Ameren Services

September 12, 2013

Subject: Comments on "10 CSR 20-7.031 Water Quality Standards" Proposed Amendment, Published in the Missouri Register June 17, 2013"

Callaway Energy Center

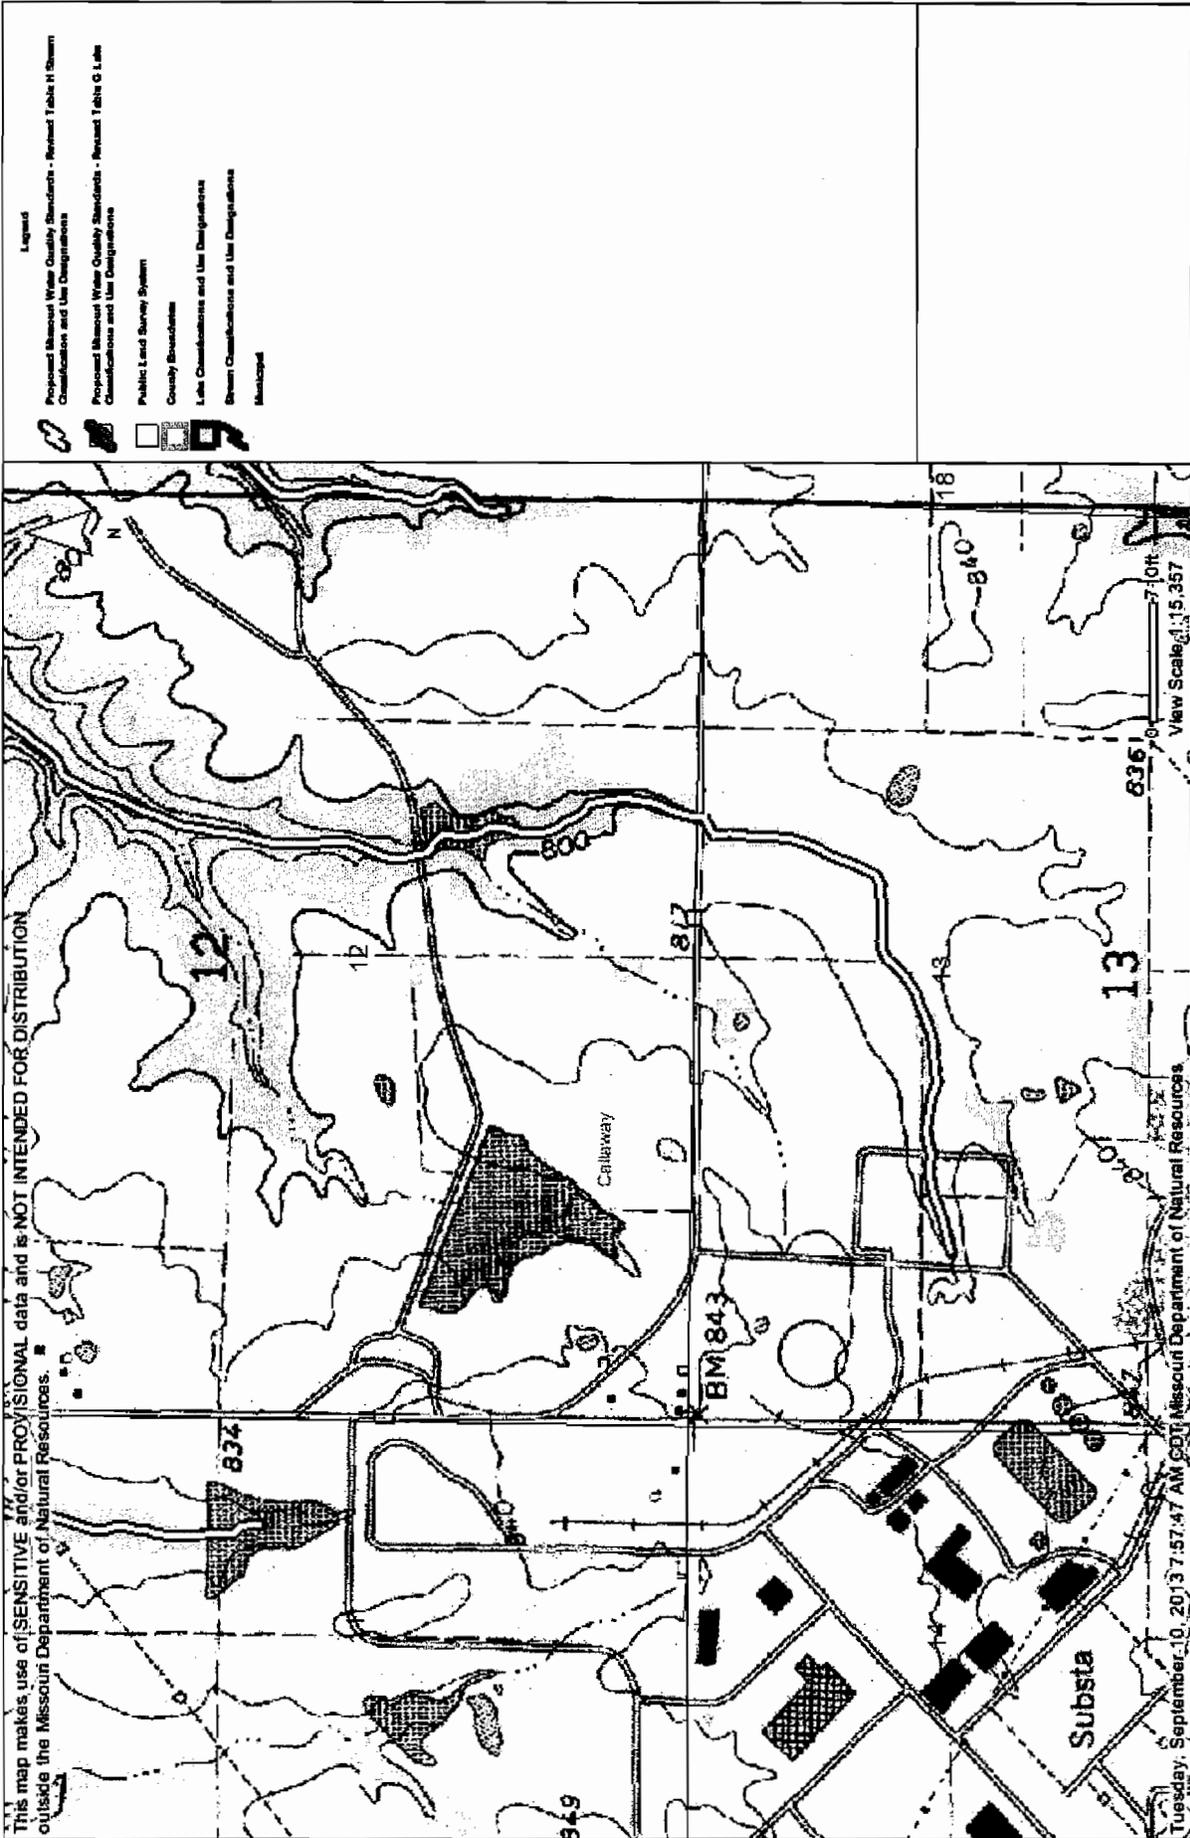
Two proposed stream segments extend into and upstream of existing, permitted on-site storm water runoff settling ponds. These ponds were constructed with the plant's construction during the 1980's and their overflow structures have been included as designated outfalls in the facility's NPDES permit for many years. As treatment basins, they and upstream conveyances contained wholly within the industrially developed Energy Center property, are clearly not waters of the state.

1. A short stream segment (less than 300 feet long) extends into one settling pond and upstream of its designated outfall #015. The classified segment should not extend above the outfall at these UTM coordinates: Easting 605919, Northing 4292281
2. A longer stream segment (approximately 4500 feet) extends into and upstream of another settling pond, continuing well upstream of its designated outfall #011. The classified segment should not extend above the outfall at these UTM coordinates: Easting 607135, Northing 4291899.

We request that the maps and Table H designations for both of these proposed classified stream segments be revised to end at the designated outfall locations specified above.

Taum Sauk Plant UR Site

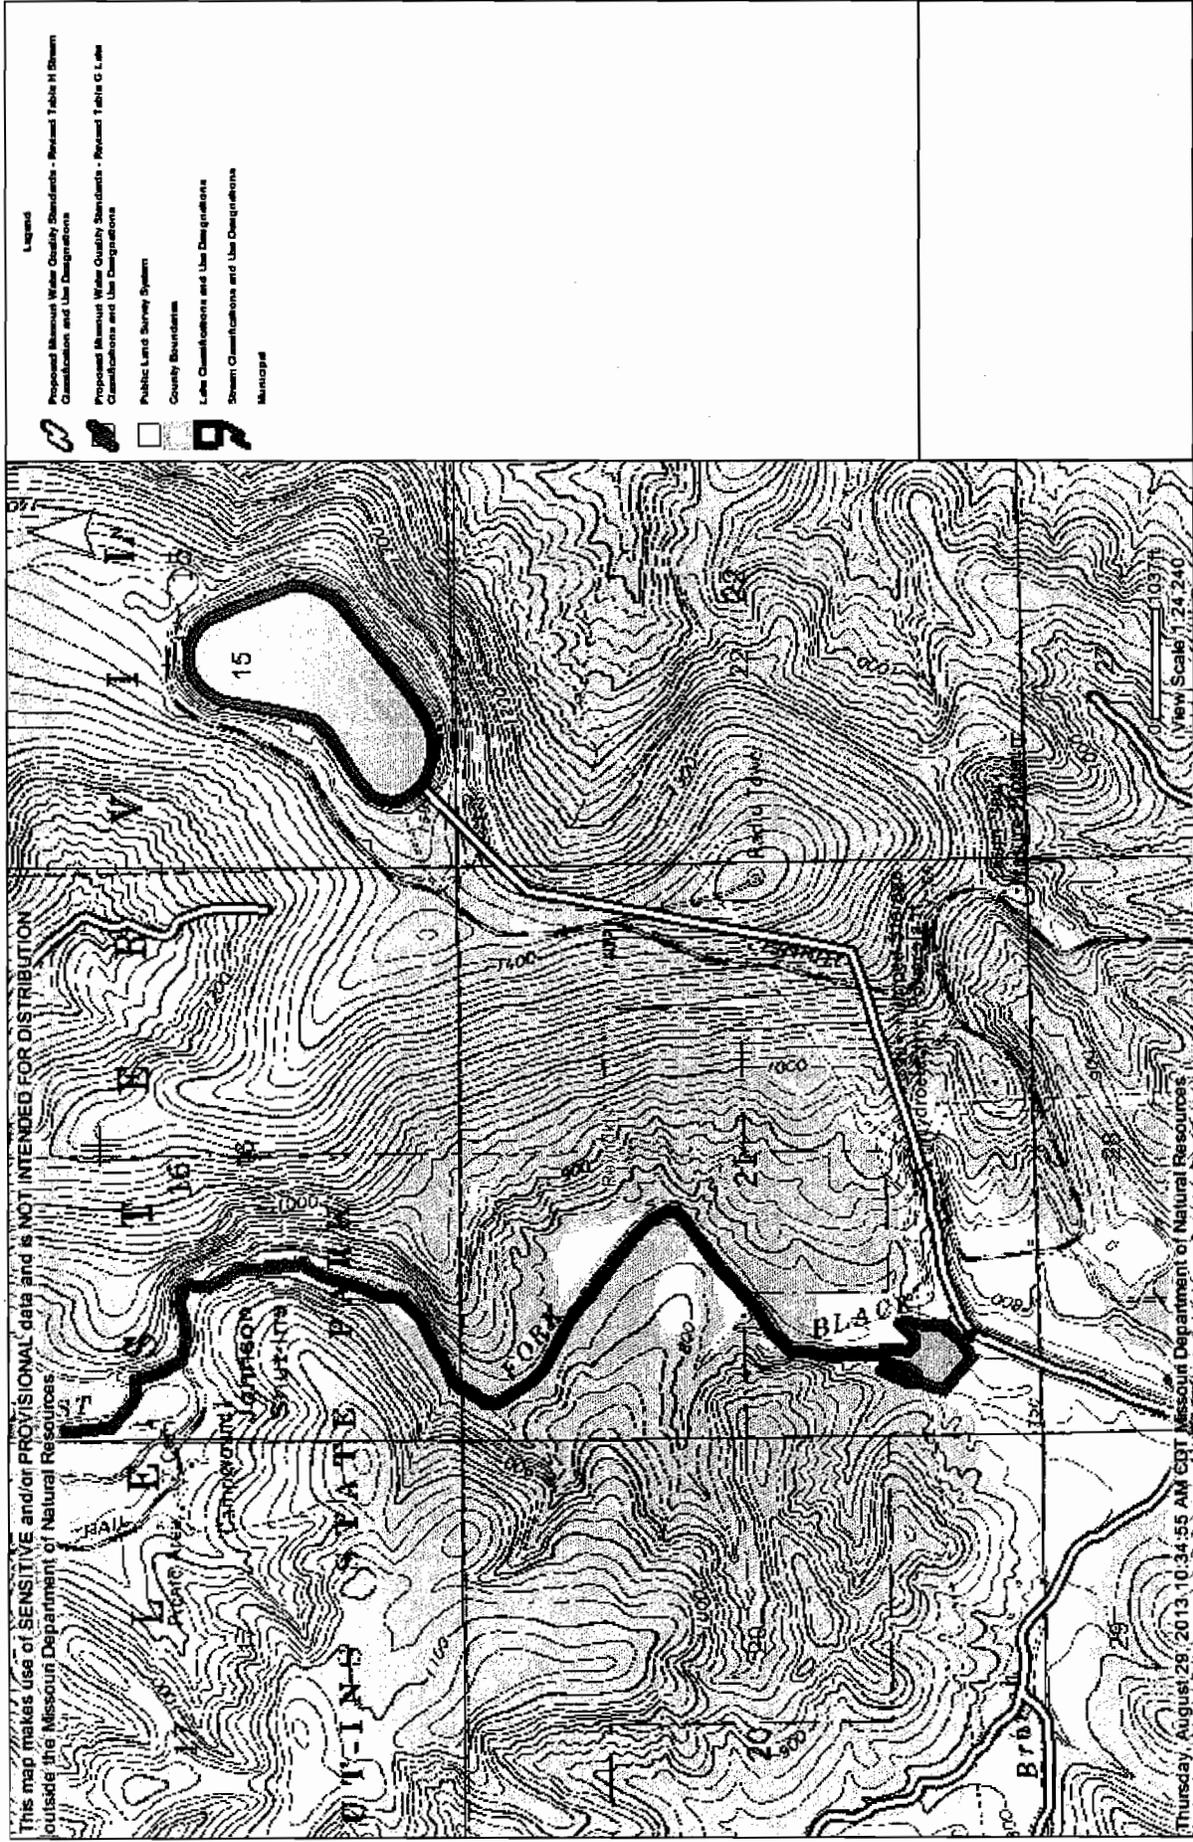
1. While seeking authorization for the recent rebuild, the US Army Corps of Engineers concluded that the Upper Reservoir was not a "waters of the US". The Department similarly concluded that the Upper Reservoir was not a waters of the State, as reflected in their 2011 issuance of a revised permit for the rebuilt facility which included a new no-discharge outfall #006, authorizing pump-back of seep water to the Upper Reservoir (in lieu of local discharge via this outfall, to waters of the state). In contrast with these determinations, the Upper Reservoir is proposed as a new lake. The UTM general coordinates (selecting a point within the 55 acre site) are: Easting 692727, Northing 4156502.

Taum Sauk Plant LR Site

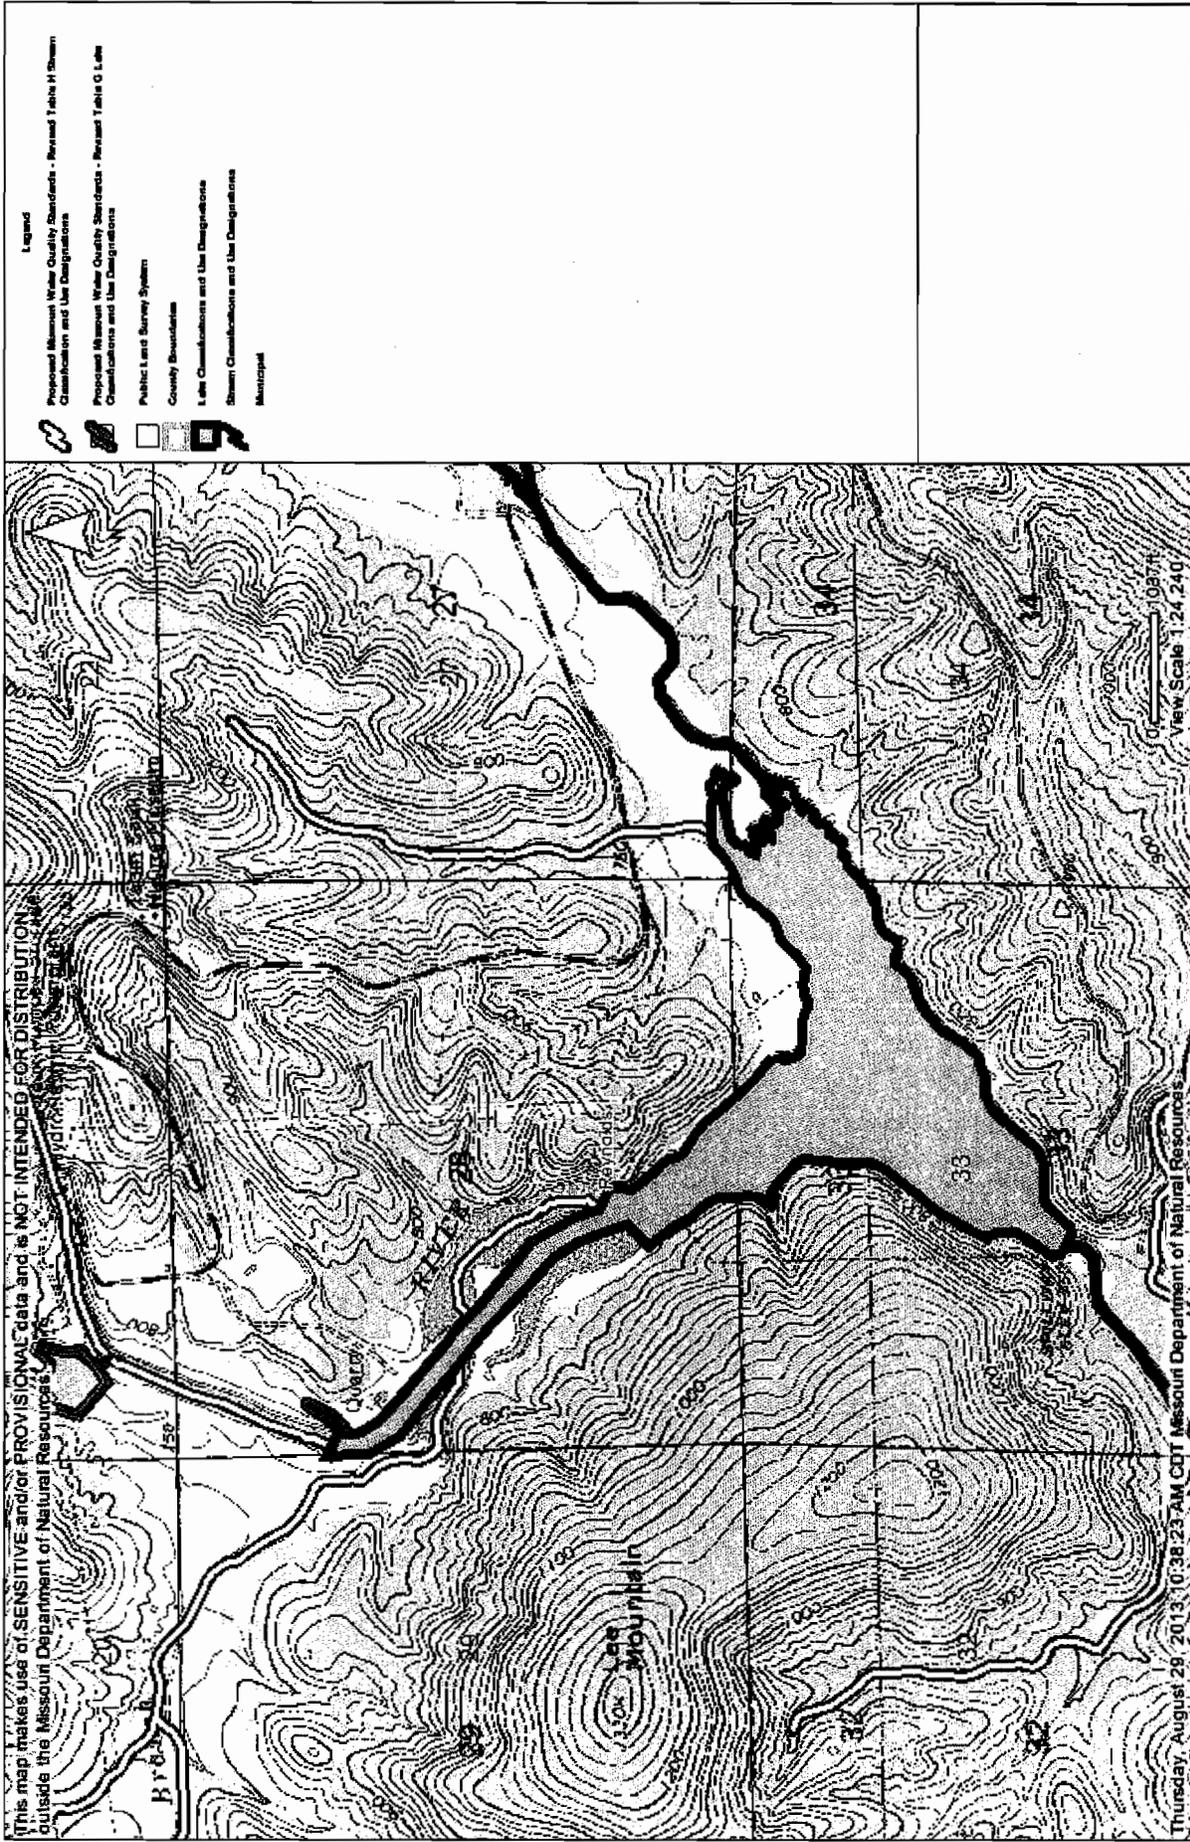
2. A segment of the East Fork of the Black River, an existing classified stream, is proposed for listing as a lake. The proposed area is just upstream of the Bin Wall, which was constructed to trap gravel and prevent accumulation within the Lower Reservoir, in conjunction with the construction of the dam which created the Lower Reservoir. Gravel within the stream above the Bin Wall is periodically (typically every three to five years) removed and placed at an upland site. We acknowledge that the stream bed in this area may be temporarily inundated during (full) drain down cycles, yet it remains a currently listed flowing stream segment. We see no justification to revise the existing stream designation by converting it to a lake classification. The UTM coordinates, centered on this water body are: Easting 690821, Northing 4154806.

4. An approximately 2,000 foot long open channel (including the Tailrace section) was excavated (during initial construction) to connect the pump-generating Plant to the East Fork of the Black River at the upstream end of the Lower Reservoir impoundment. This entire channel (which changes orientation and profile approximately at the Bin Wall), lies beneath the water surface of the Lower Reservoir, even during minimum Reservoir elevation. Yet this entire channel is proposed as a new stream segment and is mistakenly not included in the existing, lake designation (as depicted on the Map Viewer). The approximate UTM coordinates for this 'arm' of the Lower Reservoir are: Easting 690758, Northing 4154419. For reference, the coordinates for the upper and lower ends of this arm or segment are: at the face of the Plant - Easting 691394, Northing 4154861 and at the downstream intersection (with the existing lake designation of) the Lower Reservoir – Easting 690631, Northing 4154083. As further explained below, the boundaries of the existing classified lake should be expanded and this proposed stream segment deleted.

Existing or Newly Proposed Reach of ESR or LR

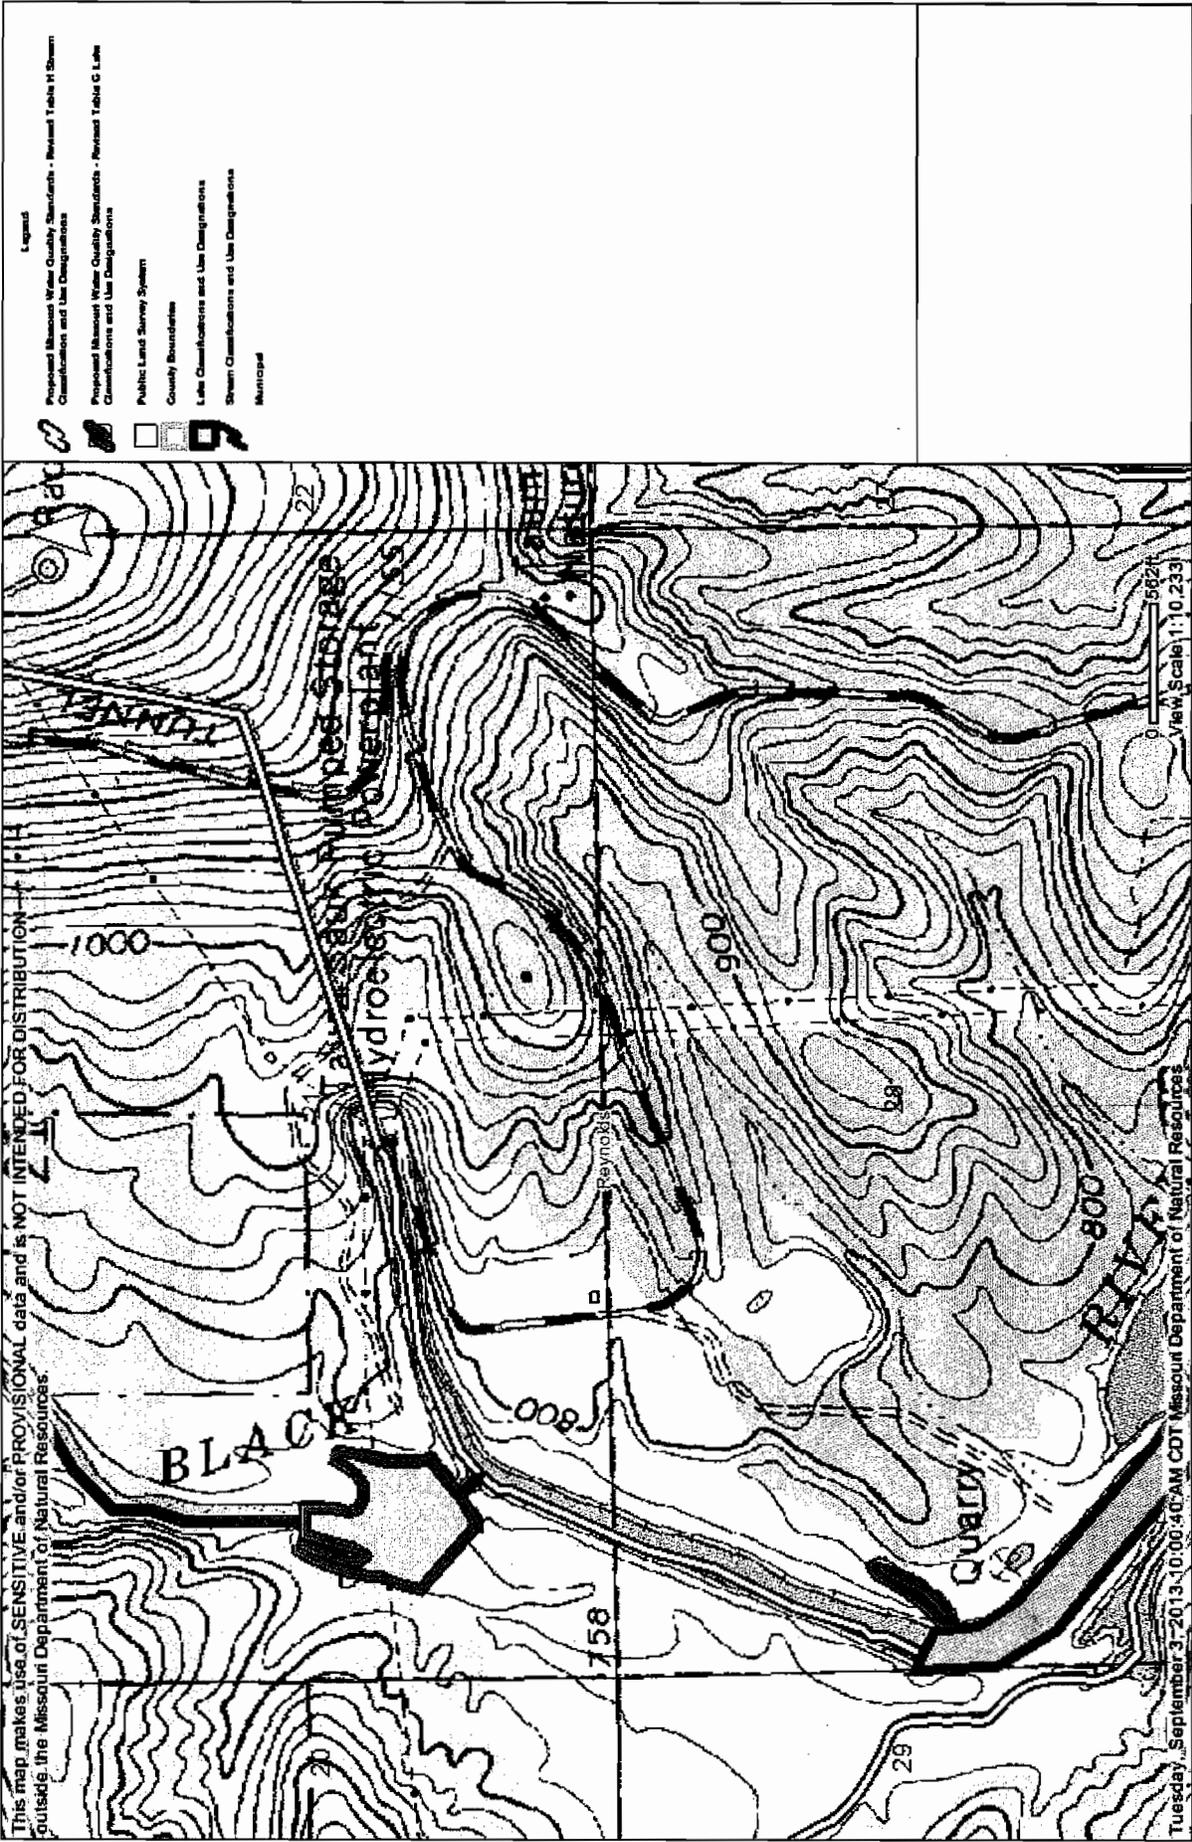
3. Water flows between the Upper and Lower Reservoirs via the following conduits: a 451 foot long, 27.2 foot diameter vertical shaft (the top 100 feet of which is lined), a 4,765 foot long, 25 foot diameter (unlined) tunnel and a 1,807 foot long, 18.5 foot diameter (steel lined) tunnel and a short penstock leading to the reversible pump units. This entire, man-made, sub-surface conveyance is proposed as a new classified stream. It should be deleted. The UTM coordinates for a central location along the proposed segment are: Easting 692009, Northing 4155346.
